MIL-M-28787/239A
AMENDMENT 2
30 July 1993
SUPERSEDING
AMENDMENT 1
12 December 1983

MODULES, STANDARD ELECTRONIC

DRIVER, NTDS SLOW, DIGITAL, KEY CODE QBQ

FIGURE 6. Vout (low-loaded) test circuit for table IV.

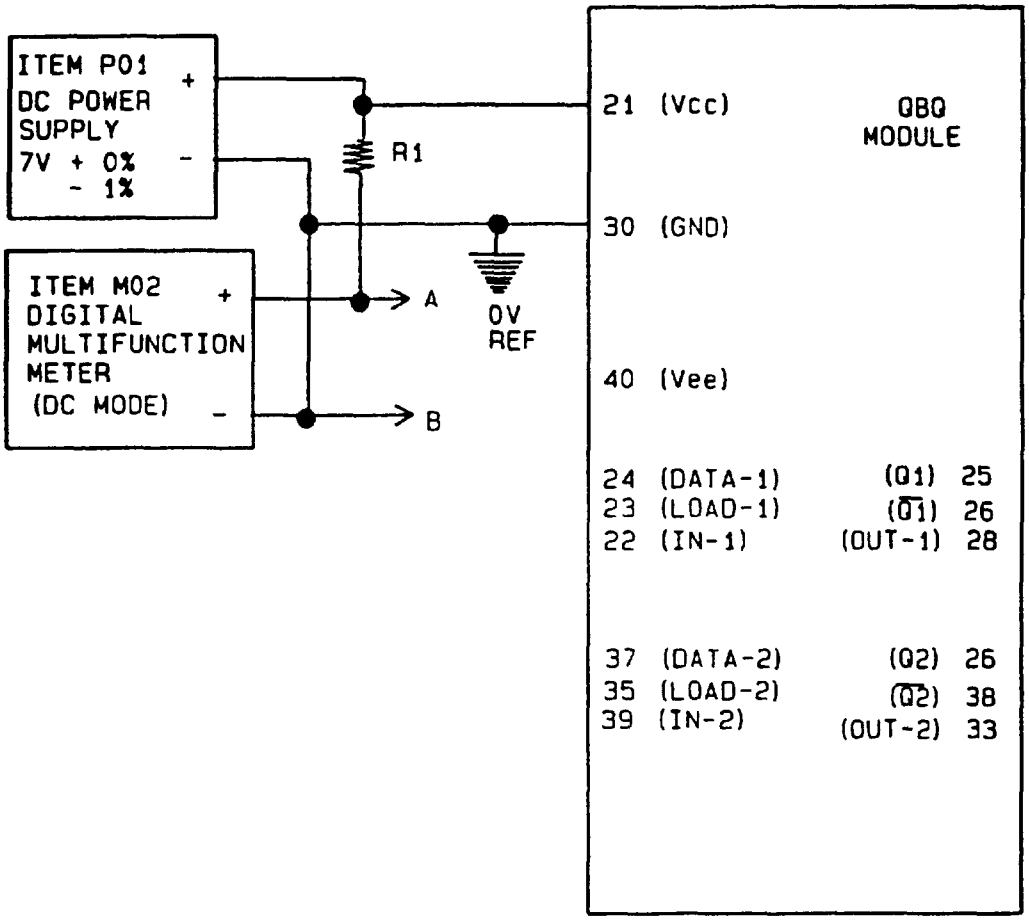
FIGURE 6: Delete and substitute new figure 6 as printed on page 4 of this amendment.

NOTES:
1. R1 = 536 Ohm ± 1%, 1/4W.
2. After point A has been connected to the appropriate module pin, monitor the output for a minimum of 10 seconds before making the measurement.

FIGURE 9. Output voltage (low-level and high-level) test circuit for table VII.

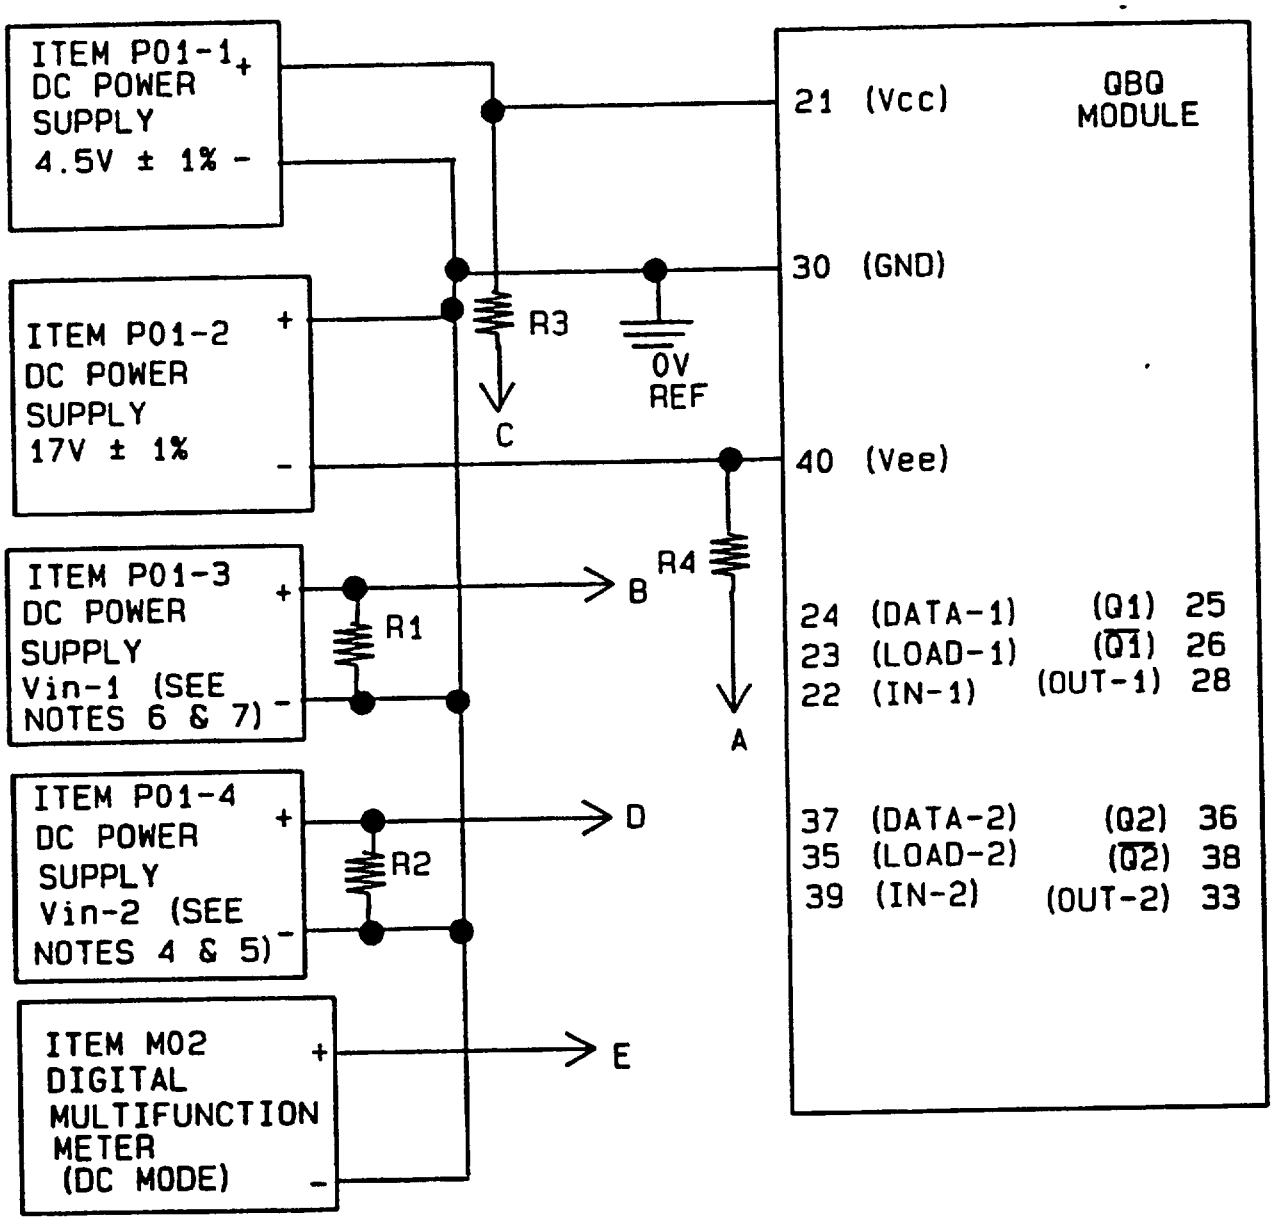
FIGURE 9: Delete and substitute new figure 9 as printed on pages 5 and 6 of this amendment.

1. R1 = R2 = 51 Ohm ± 5%, 1W.

2. R3 = 3.65 kOhm ± 1%, 1/8W.

3. R4 = 976 Ohm ± 1%, 1/2W.

4. For test conditions E1, E3, F2 and F4:
   Vin-2 = 0.8V ± 1%.

5. For test conditions F5 and F6:
   Vin-2 = 0.7V ± 1%.

6. For test conditions E1-E4 and F1-F4:
   Vin-1 = 2.0V ± 1%.

7. For test conditions E5 and E6:
   Vin-1 = 3.5V ± 1%.

8. Load Q and $\overline{Q}$ outputs of circuit under test with a load as specified on figure 10.

FIGURE 13. Input current (low-level) test circuit for table X.

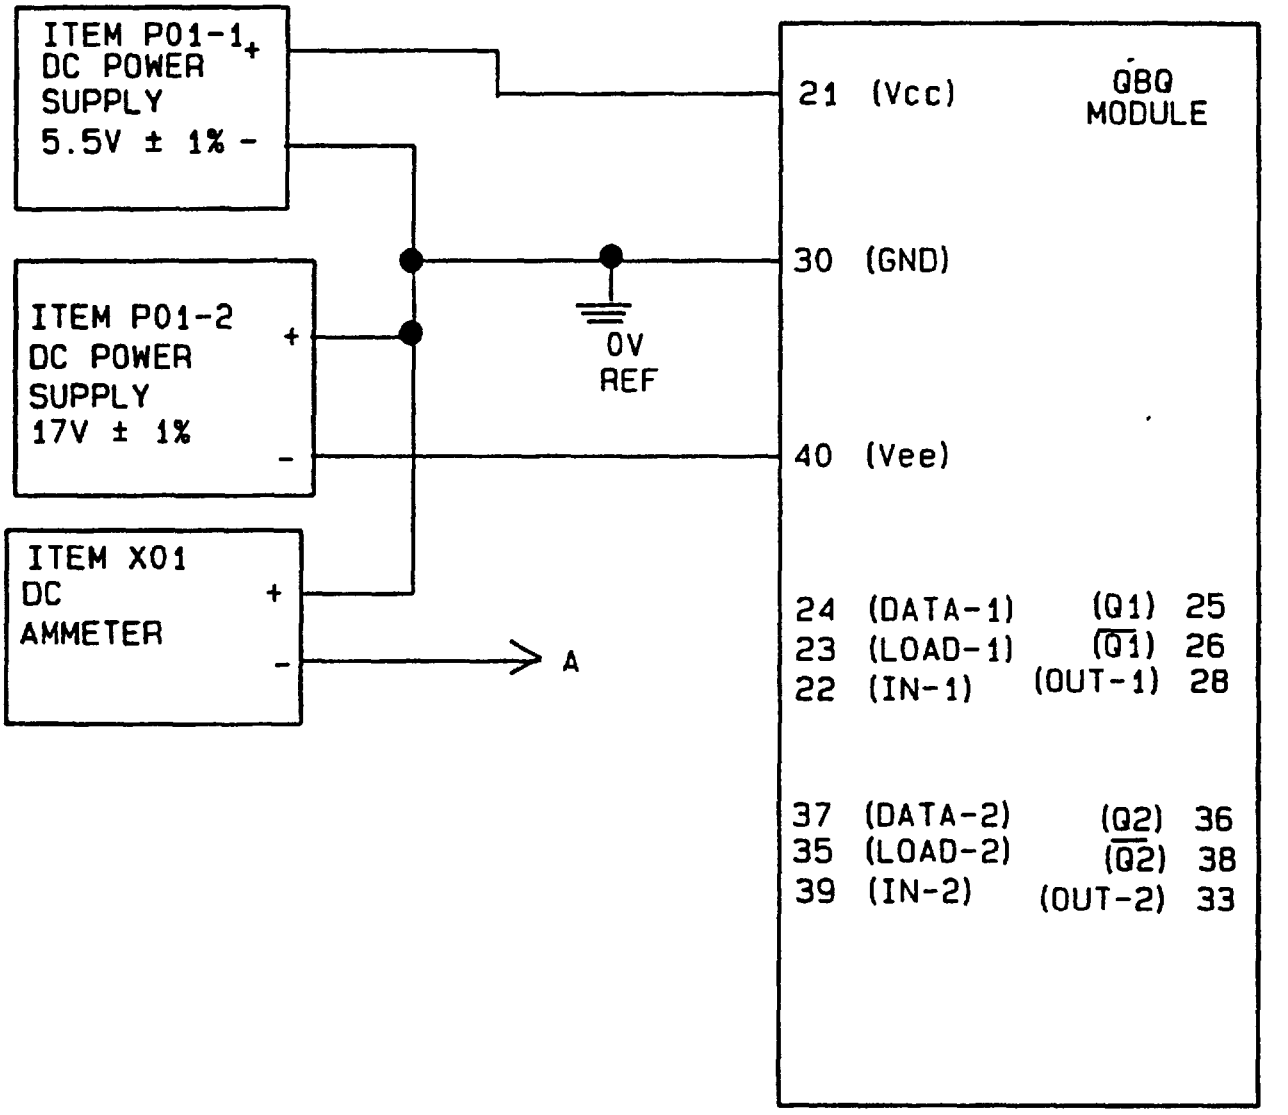
FIGURE 13: Delete and substitute new figure 13 as printed on page 7 of this amendment.

CAUTION:
Do not isolate the chassis of ammeter X01 from earth ground.
